ENBRIDGE GAS INC.
Answer to Interrogatory from
Energy Probe Research Foundation (EP)

Reference: Exhibit A1, Tab 5, Schedule 2, Conditions of Service Section 6.4.1: Exhibit A1, Tab 5, Schedule 4.

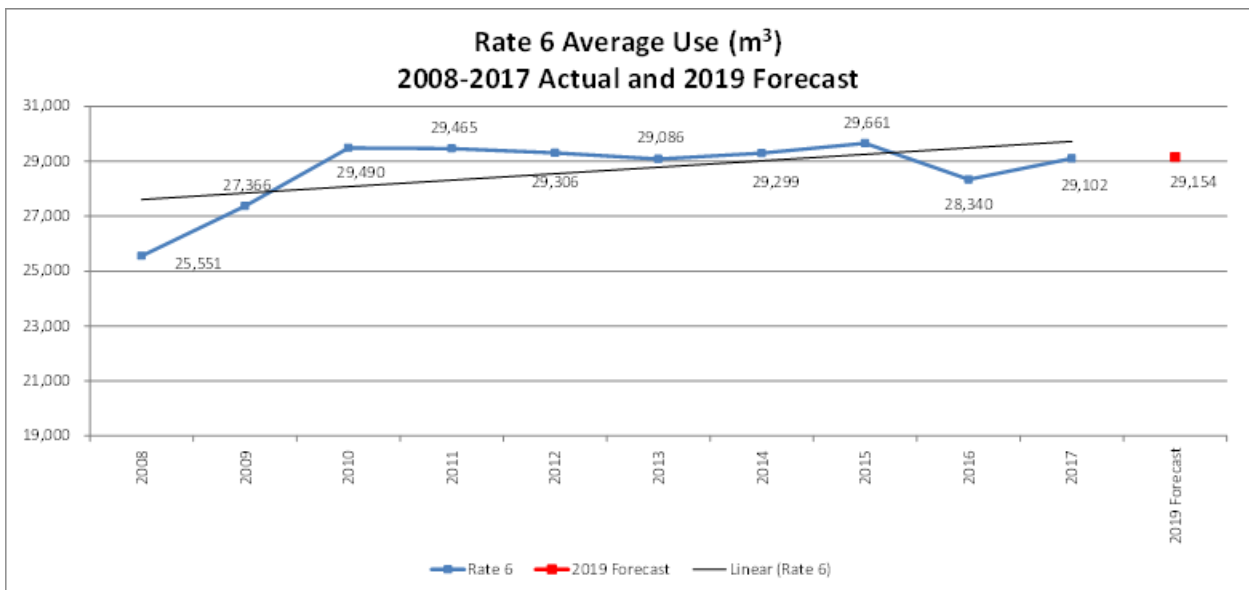
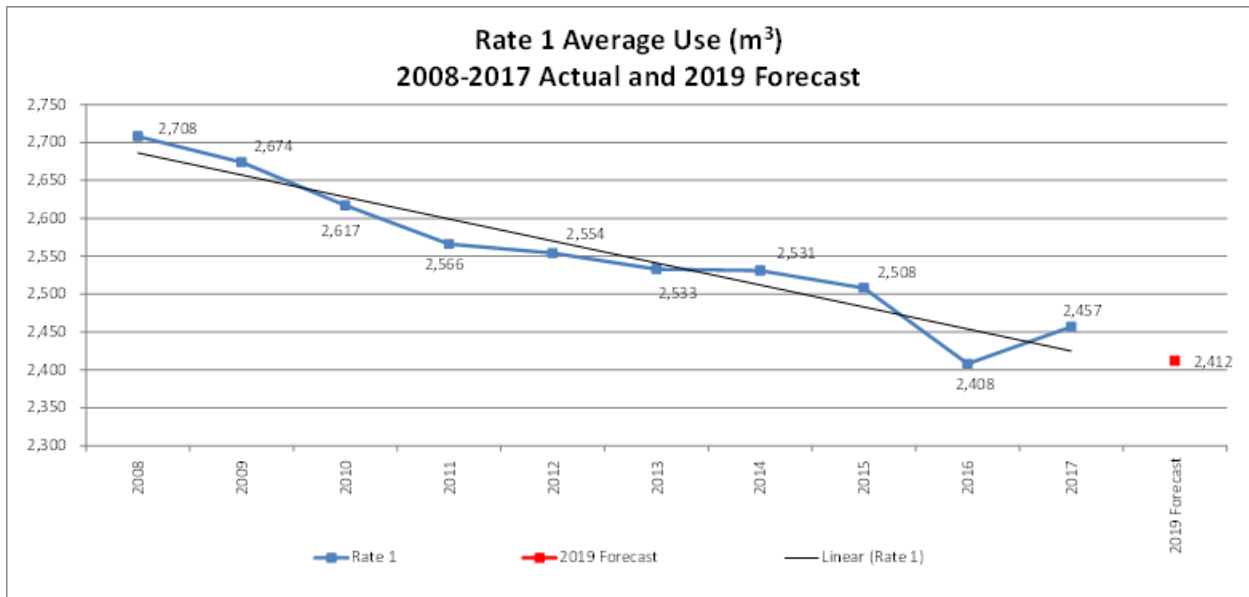
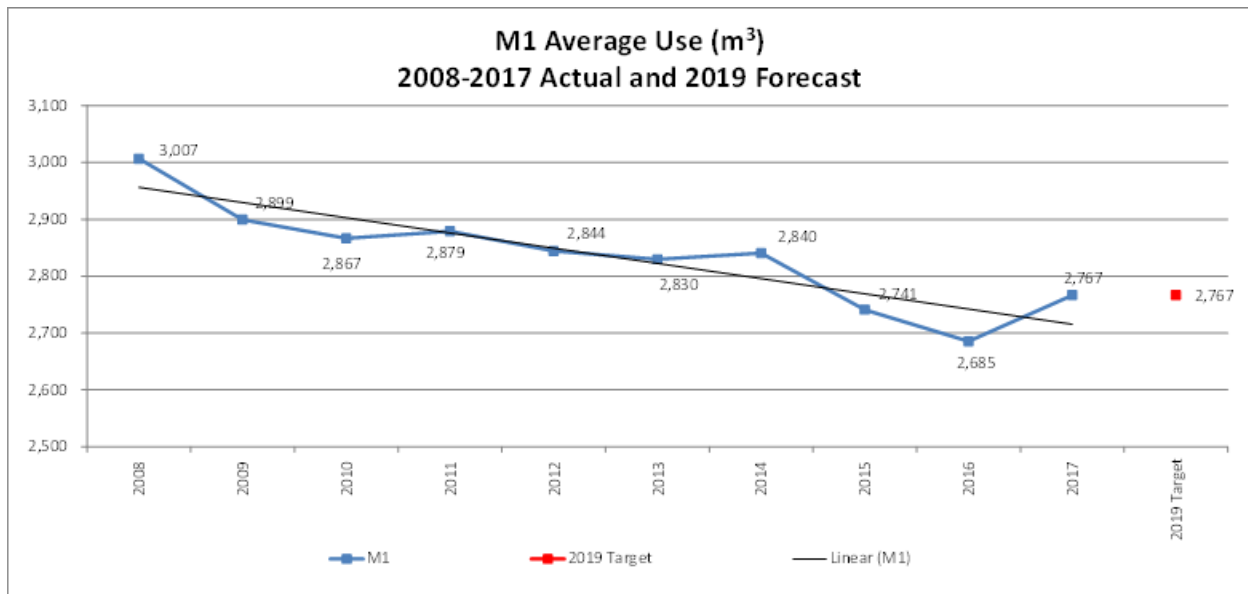
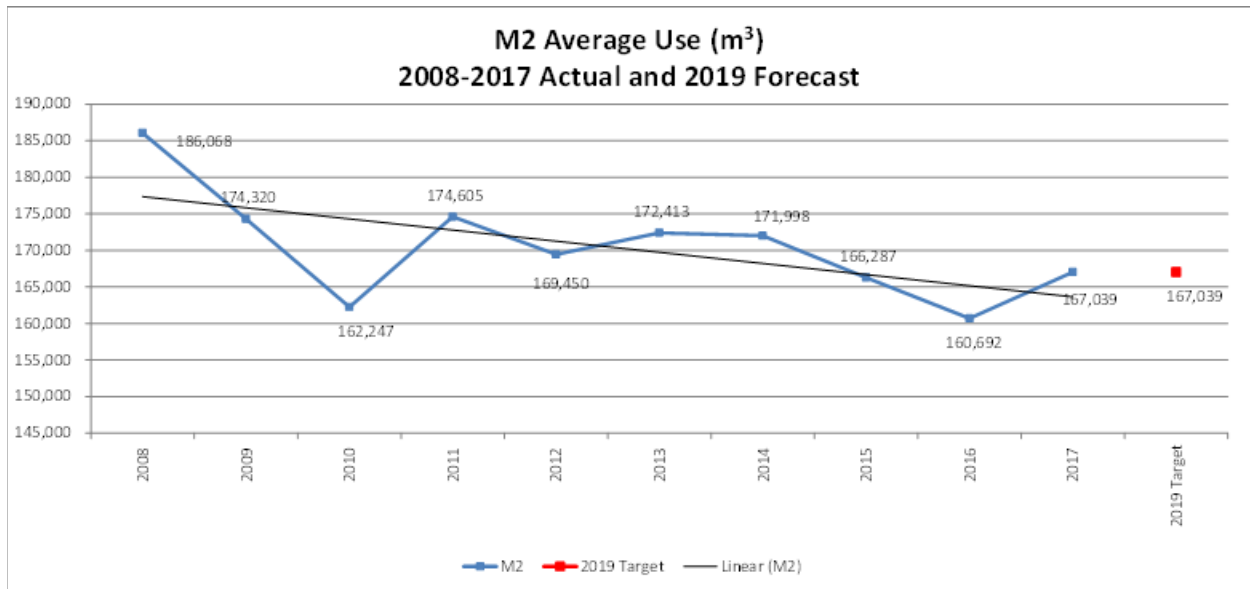
- a) Please show Graphically, for Rate 1 and Rate 6, the average use for the last 10 years and for the forecast period. Please provide a comment on the accuracy of the model and trends.
- b) Please provide a status report on the review of Average Use models for EGD as agreed in the EB-2017-102, Settlement at Exhibit N1, Tab 1, Schedule 1, page 8

- c) Please show Graphically for Rate M1 and M2, the average use for the last 10 years and for the forecast period. Please provide a Comment on the accuracy of the model and trends.
- d) Please provide a status report on the review of Average Use models for Union as in the EB-2016-0118 Settlement paragraph 12.

- a) The Rate 1 and 6 average uses that are normalized to 2019 Board approved degree days are shown in the charts below.

The 2019 forecast is developed using the data up to 2017. During the last 10 years Rate 1 average use declined 9.3% from 2,708 m³ in 2008 to 2,457 m³ in 2017. Rate 6 in the same period increased 13.9% from 25,551 m³ in 2008 to 29,102 m³ in 2017. For accuracy results, please see Exhibit I.STAFF.5, part a) Table 1, which provides the 10-Year history of Normalized Actual vs. Board-Approved average

uses. Out-of-sample average percentage variance over the last 10 years is -0.5% for Rate 1 and 0.5% for Rate 6. The results support the view that the General Service average use forecasting methodology continues to be a reliable predictor for General Service average use.

- b) As per the Board’s Decision and Order in the MAADs and Rate Setting Mechanism proceeding, Enbridge Gas will develop a proposal for the average use methodology for its next rebasing application.¹
- c) The weather normalized average use at the 2019 Board approved normal, for Rate M1 and Rate M2 are shown in the charts below.

Over the last 10 years, Rate M1 NAC declined 8.0% from 3,007 m³ in 2008 to 2,767 m³ in 2017. Rate M2 NAC for the same period decreased 10.2% from 186,068 m³ in 2008 to 167,039 m³ in 2017.

When adjusting rates each year for changes to NAC, Union applies the most recent actual NAC for each rate class, calculated using the Board-approved 50:50 weather normal for the forecast year. For 2019 rates, 2017 actual NAC calculated using the 2019 weather normal is used for each rate class.

Because of actual customer behavior in each rate class, there has been some variability from year to year in the actual NAC, with an overall declining trend. Enbridge Gas is currently evaluating methodologies regarding NAC forecasting, and will file a proposal with its next rebasing application.

Figure 12

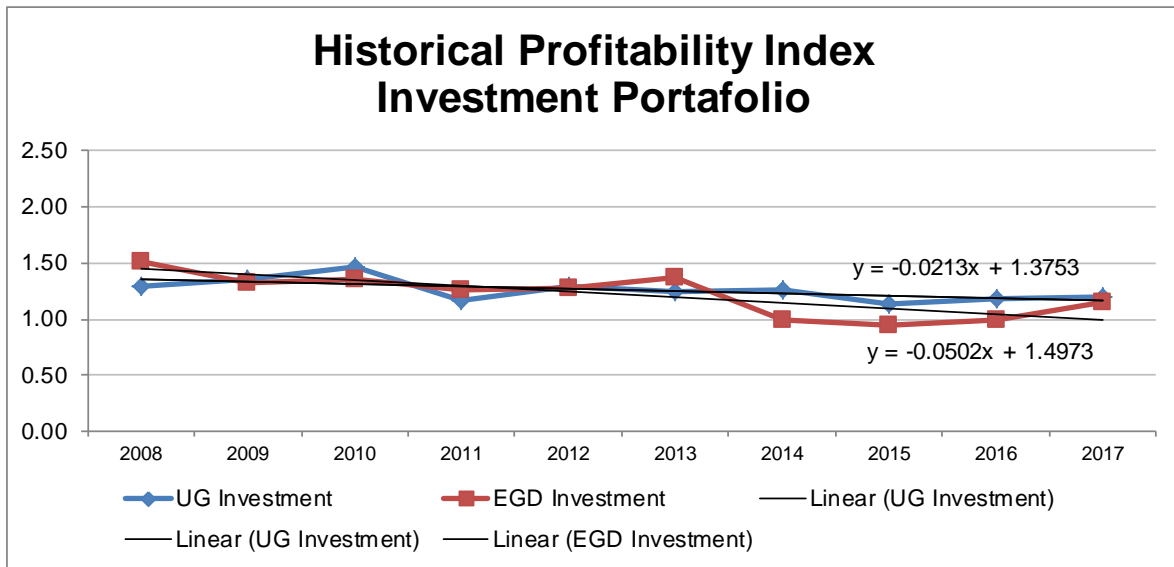
- a) Please clarify if the PI shown in the Figures is based on gross cost or net cost (less CIAC).
- b) For Figures 12 and 13 please provide the "Best Fit" Lines and provide the equations.
- c) Please explain and discuss the trends in PI for the Project and Rolling Portfolios for Union and EGD.
- d) Please provide the historic 2015+ and current approved system expansion projects for EGD and Union with summary data such as location, cost, customer additions etc.
- e) Please discuss the outlook for system expansion projects for each rate Zone. Delineate projects using SES and Government support.
- f) How much will be invested in SE during the Deferred rebasing period 2020-2025? Please reconcile to the data in the Utility System Plan.

- a) The PI shown in figures 12 and 13 are based on net cost (less CIAC).
- b) Please see below the best fit lines and the equation for Figures 12 and 13.

c) Figure 12 shows the Investment Portfolio Trend, where the slope of the best fit line for both the EGD and Union rate zones are negative, which suggests that the PI is trending down over time.
